## **AGENDA**

City of Beaufort

### **DESIGN REVIEW BOARD MEETING**

##### **A. Coastal States Bank, PIN R120 004 000 0012 0000, 1203 Boundary Street. Applicant: Dana McClure, Warner Summers Architecture (22-06 DRB.3)**

SHEET NUMBER  
**A1.0.1**

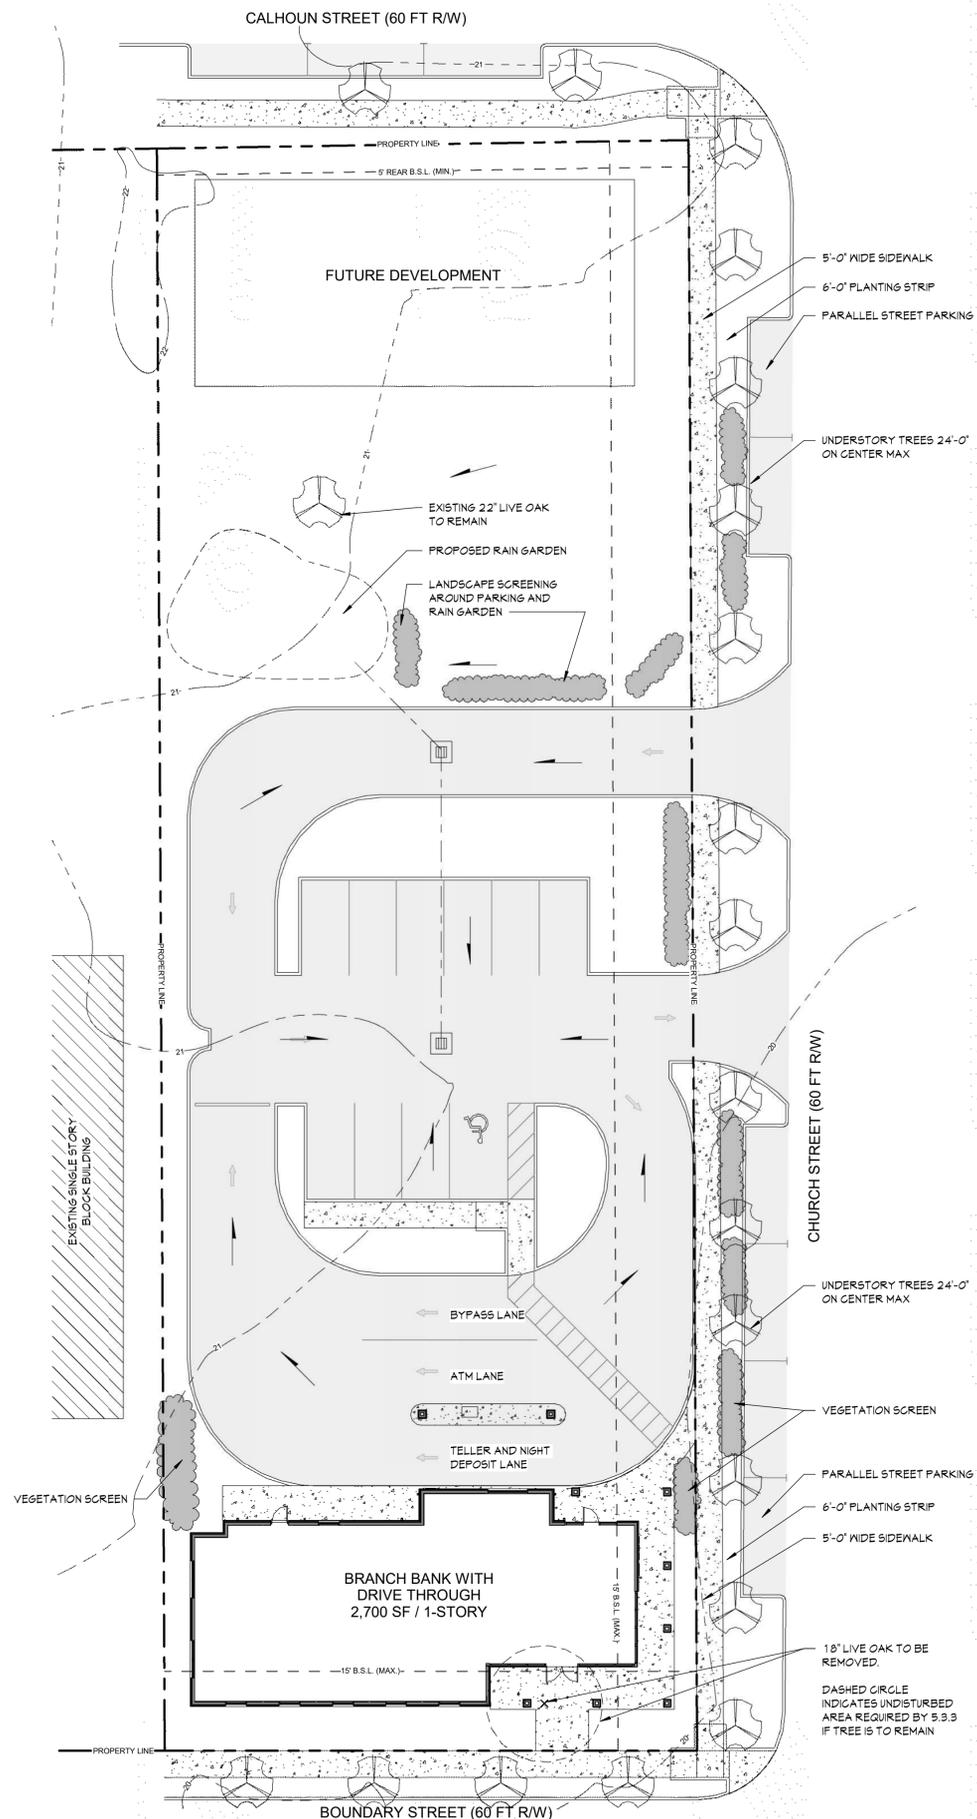
1. Site Plan Option One: while the applicant has responded to the board and staff's previous conditions, staff feels this site plan is deficient for the following reasons:
  - a. Staff does not support two curb cuts along Church Street, especially given their proximity to each other. Staff recommends moving the egress curb cut north to join the ingress curb cut. Staff recommends the northeastern most parking space be eliminated to accommodate a travel lane for egress.

- b. Per Section 5.7.8.B.3.a, "landscaped peninsulas with a plantable area of at least 12 feet wide by 18 feet long area shall be established parallel to parking spaces and at the end of the parking aisle in order to separate the last space from any adjacent driveways." Applicant's two western most peninsulas do not meet this requirement. It appears to staff, that the applicant may need to eliminate two more spaces in addition to the recommended elimination of one space in comment 1a to dimensionally meet this requirement. This will bring the onsite parking down from ten to seven parking spaces which is the minimum parking requirement.

- f. Applicant to provide more detail for the proposed vegetative screening. Applicant to include views of vegetation screening in final application renderings as stated in Board condition 6 of the June DRB Decision Letter (see Staff Acknowledgements above).

SHEET NUMBER  
**A1.0.2**

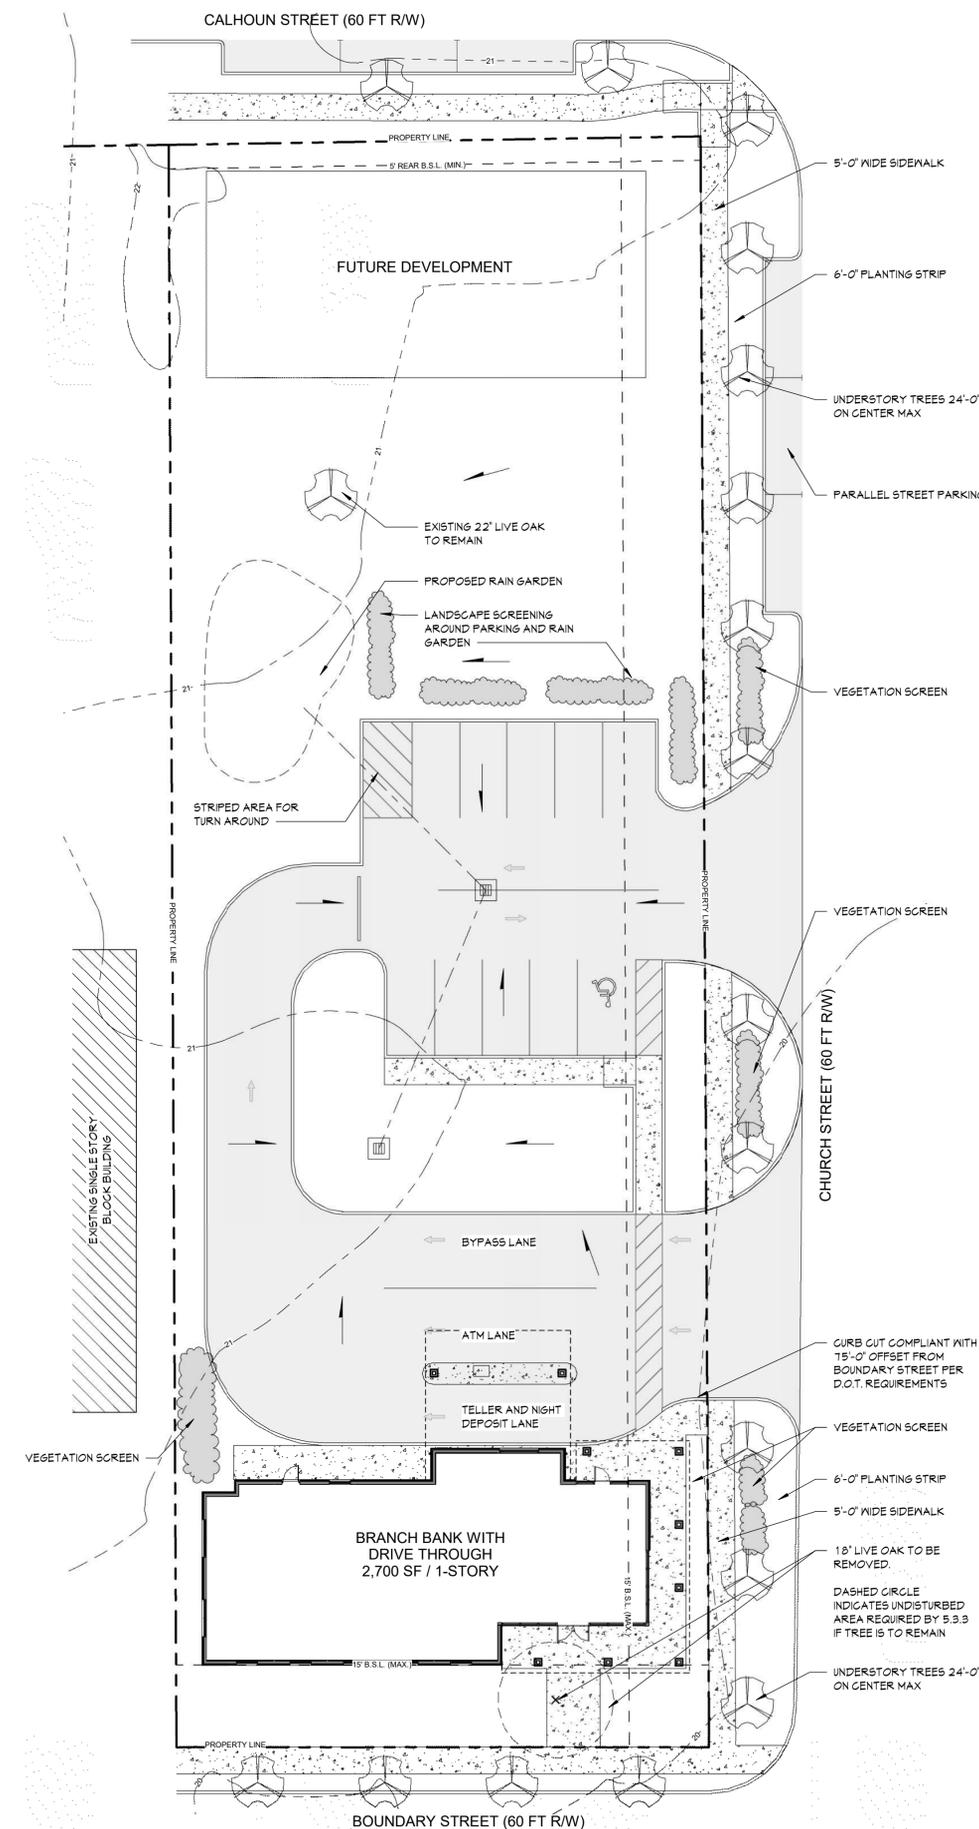
2. Site Plan Option Two: while the applicant has responded to the board and staff's previous conditions, staff feels this site plan is deficient for the following reasons:

- b. Per Section 5.7.8.B.3.a, “landscaped peninsulas with a plantable area of at least 12 feet wide by 18 feet long area shall be established parallel to parking spaces and at the end of the parking aisle in order to separate the last space from any adjacent driveways.” Applicant to demonstrate compliance with this requirement in a redesigned site plan.

- e. Applicant to provide more detail for the proposed vegetative screening. Applicant to include views of vegetation screening in final application renderings as stated in Board condition 6 of the June DRB Decision Letter (see Staff Acknowledgements above).
